May 2, 2022

**SUBJECT: Addendum to the Mitigated Negative Declaration ER20-19 for Floradale Avenue Crossing – Sewer Line Horizontal Directional Drilling**

**Figure 2. Site Map**  
Floradale Ave. HDD Project  
City of Lompoc  
Santa Barbara County, California

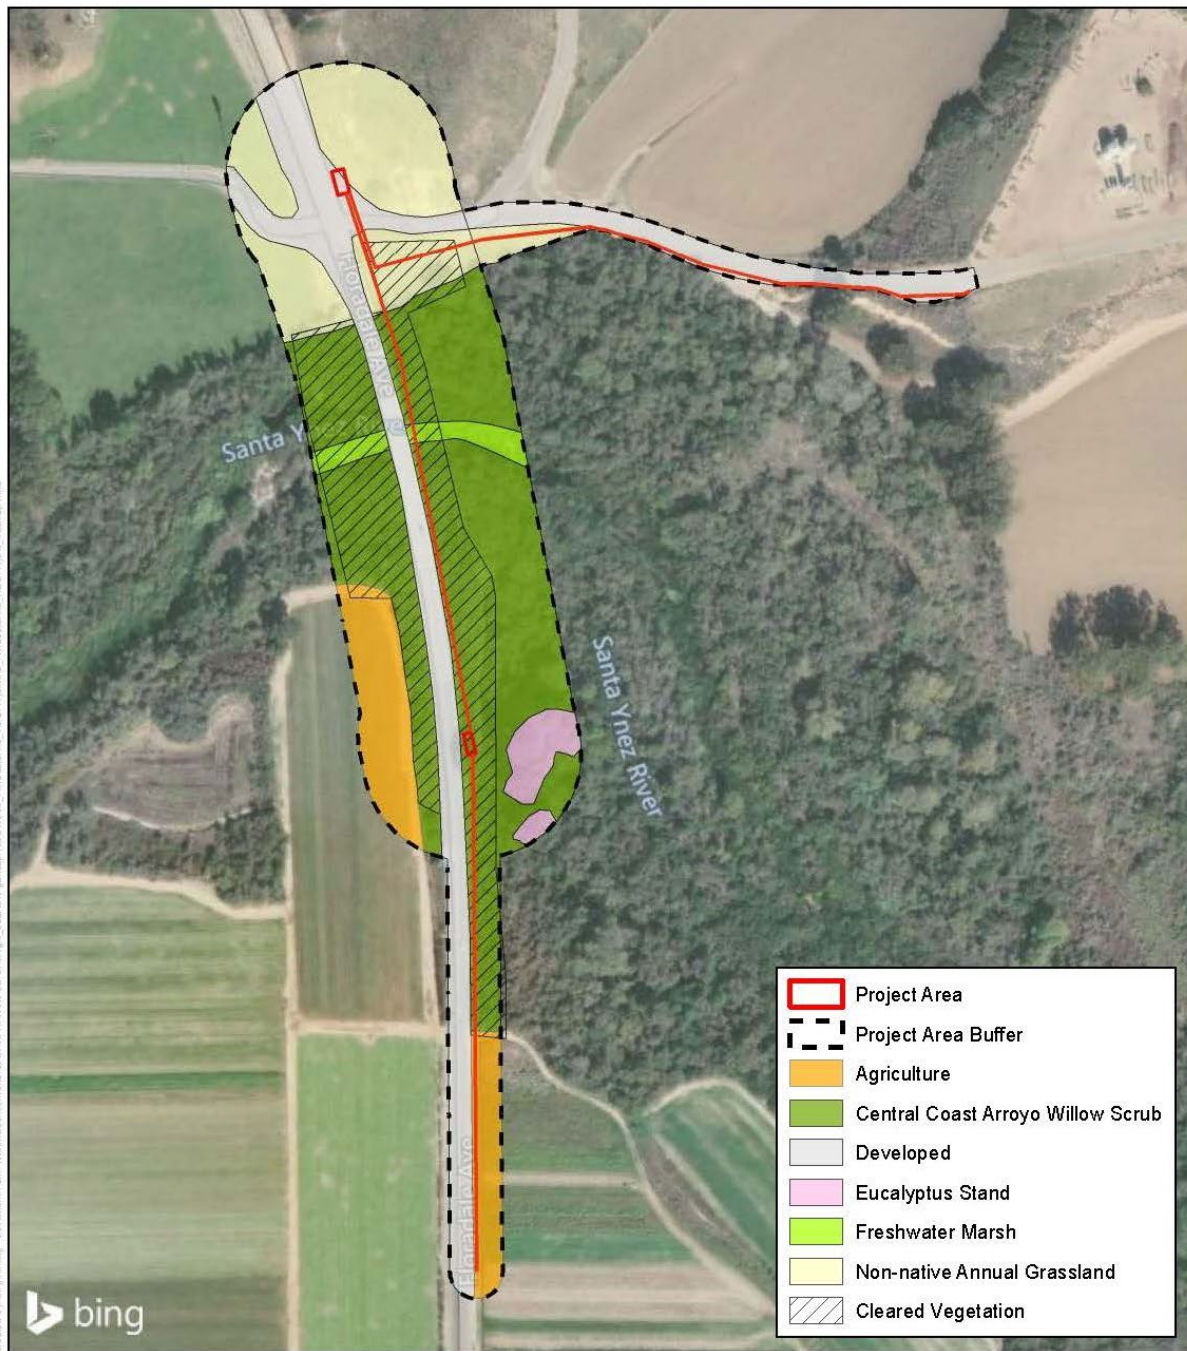
The directional drill will cross the Santa Ynez River within the existing roadway easements and rights-of-way along the east side of the existing Floradale Avenue bridge and roadway (updated Figure 2). The entrance pit is planned to be located above the upper north bank of the Santa Ynez River, along the eastern shoulder of Santa Lucia Canyon Road, north of the prison's Rancho Lompoc Farm Road, over 300 feet north of the riverbed. The exit pit is planned to be located on the upper south riverbank adjacent to Floradale Avenue, over 400' south of the riverbed, and the sewer pipe is planned to be laid along the eastern shoulder of Floradale Avenue, south of the exit pit, and then pulled into the bore hole through

the exit pit. The directional drill alignment is planned to be approximately 1,200 feet long. The open trench portion of siphon sewer line replacement to connect to the existing upstream gravity sewer line will be approximately 1,310 feet long and begin at the HDD staging area on the eastern shoulder of Santa Lucia Canyon Road north of Rancho Lompoc Farm Road and continue south, crossing the farm road, and then turn east and follow the southern edge of the farm road to connect with the existing gravity sewer line (updated Figure 2).

The HDD sewer lines will be placed east (upstream) of the existing Floradale Avenue bridge, extending from the southeast side of the existing bridge, under the Santa Ynez River to the northeast side of the existing bridge.

The approximately 1,310-foot open trenched portion of siphon sewer line replacement will begin at the HDD staging area on the eastern shoulder of Santa Lucia Canyon Road north of Rancho Lompoc Farm Road and after crossing the farm road to the south, the pipeline will continue east and be installed immediately adjacent to the north side of the existing pipeline, at or near the southern edge of the farm road. A 3-foot-wide trench will be excavated to install the new pipe and the existing pipeline will be abandoned in place.
